UNC Charlotte Phase 16

Addendum #4

Revision Narrative

2021-09-08

E-010

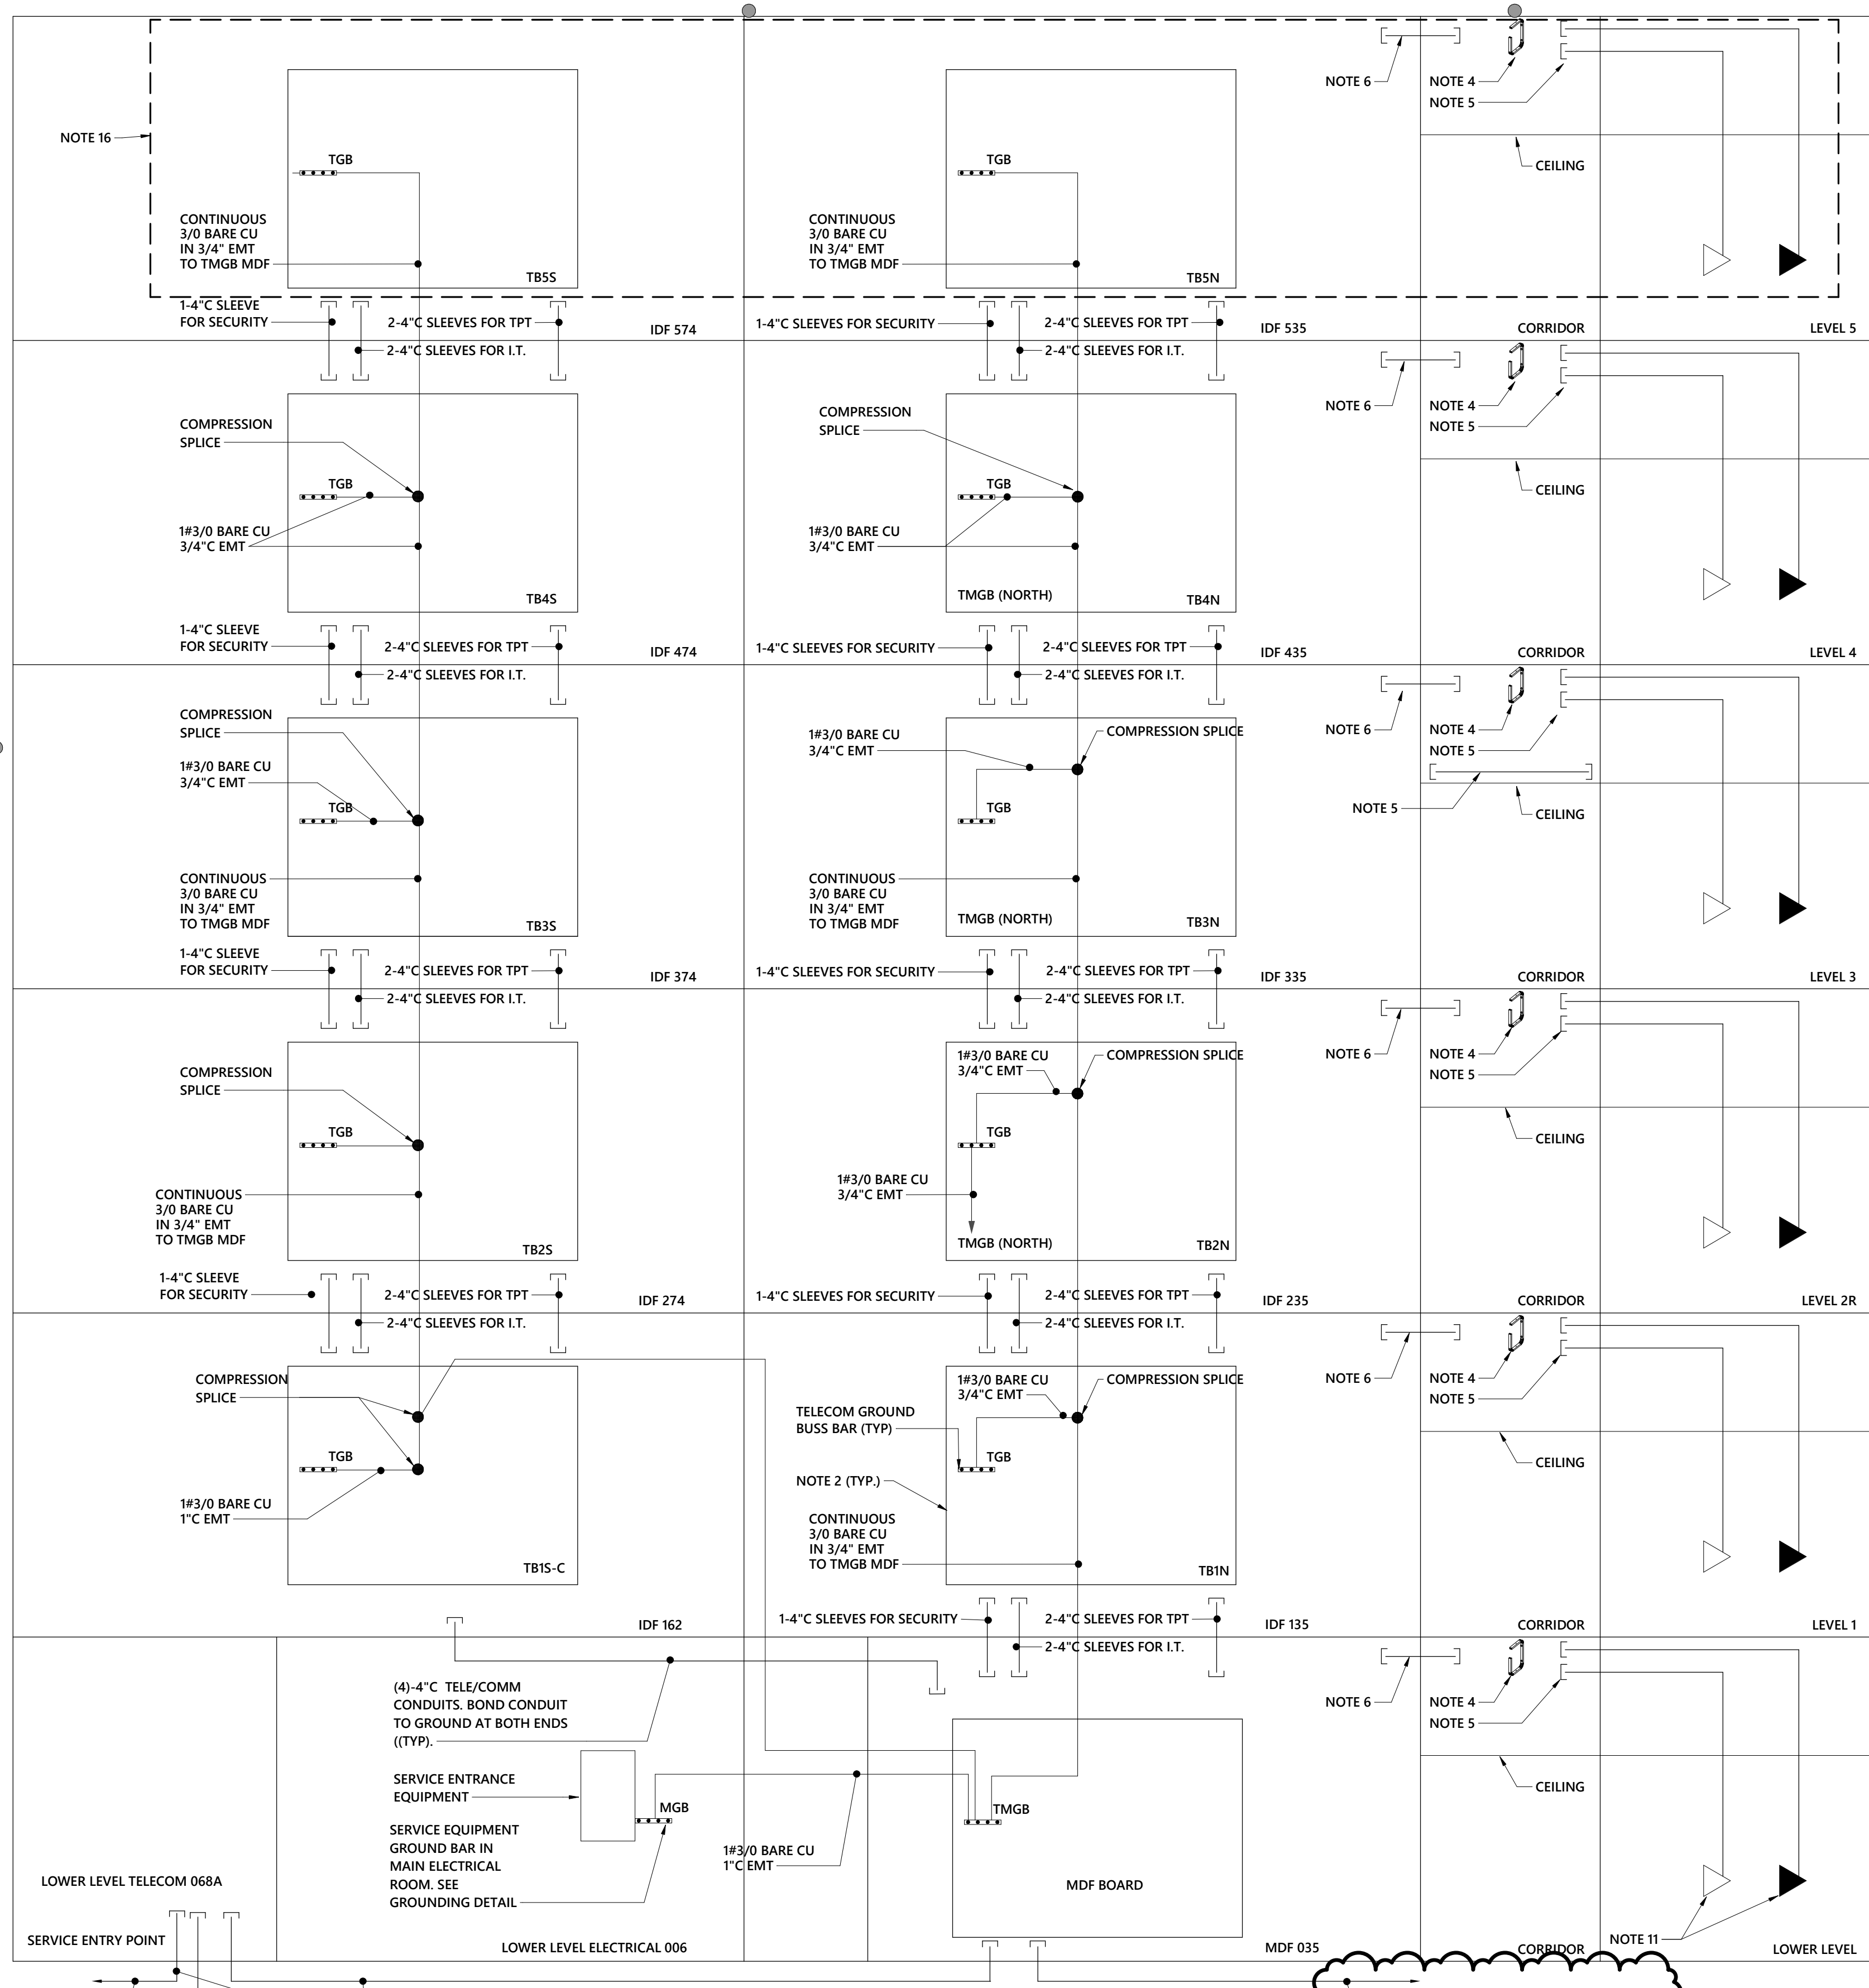
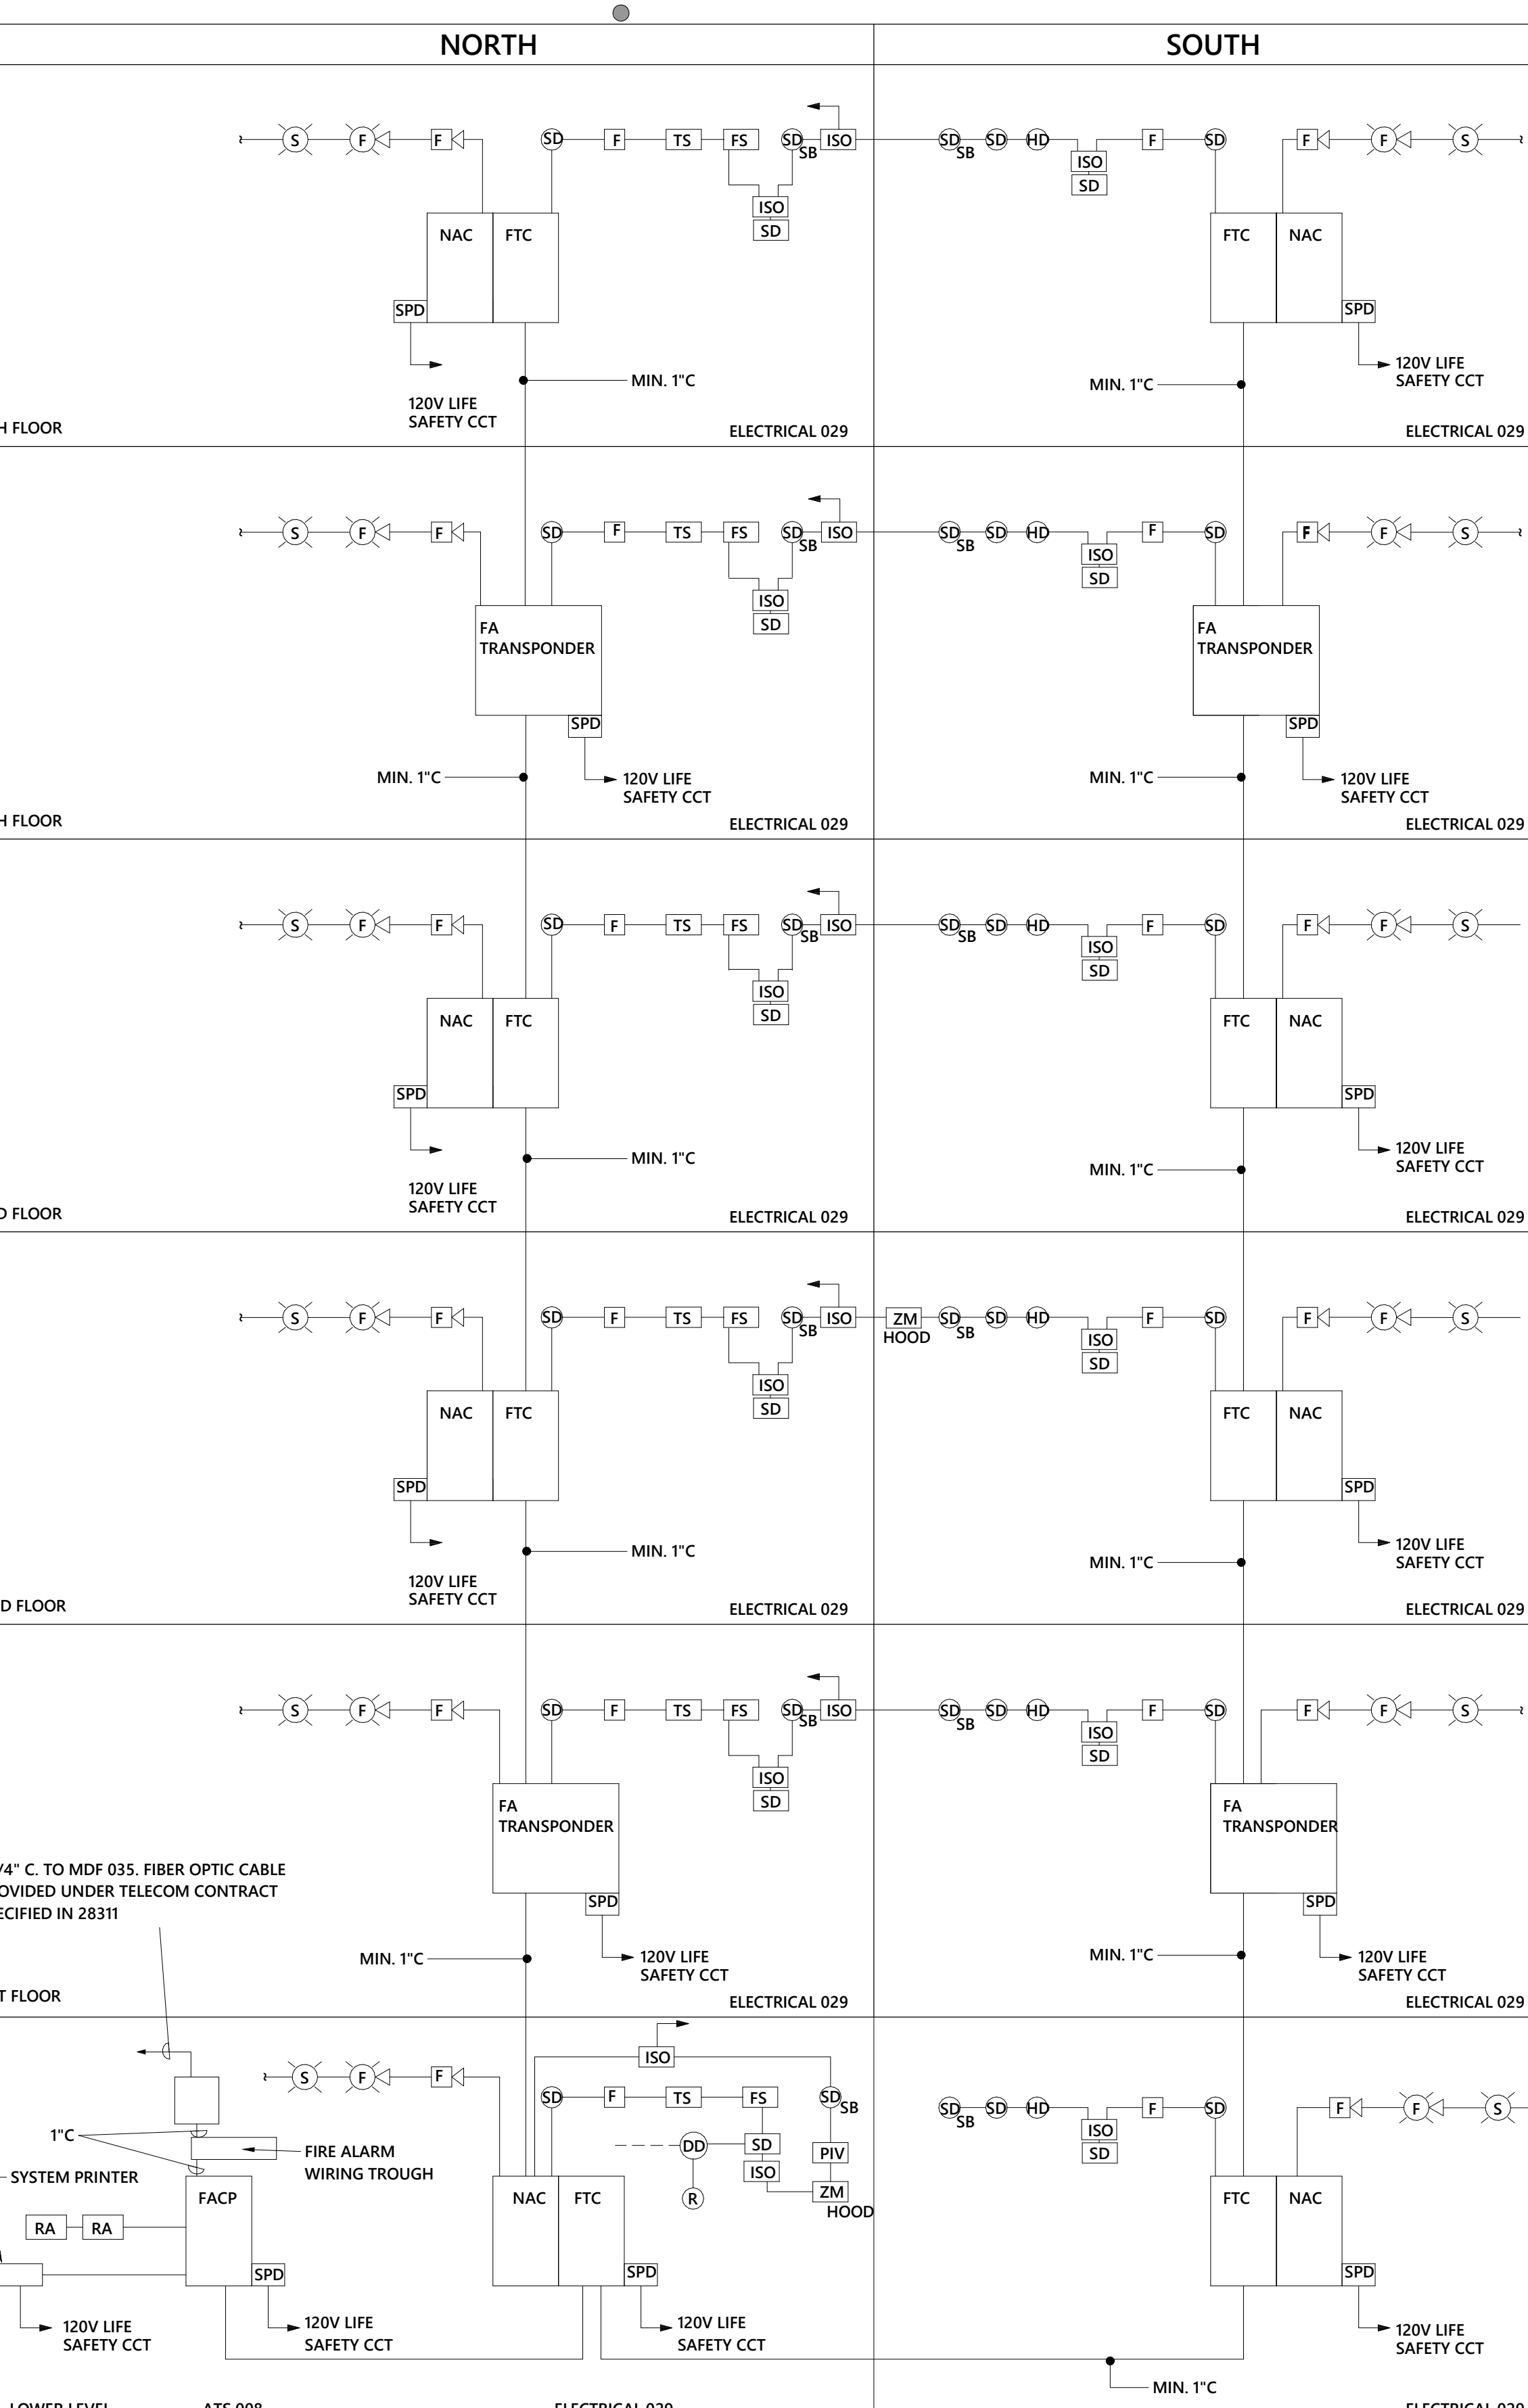
E-010 - Alternate information removed. Base bid only.
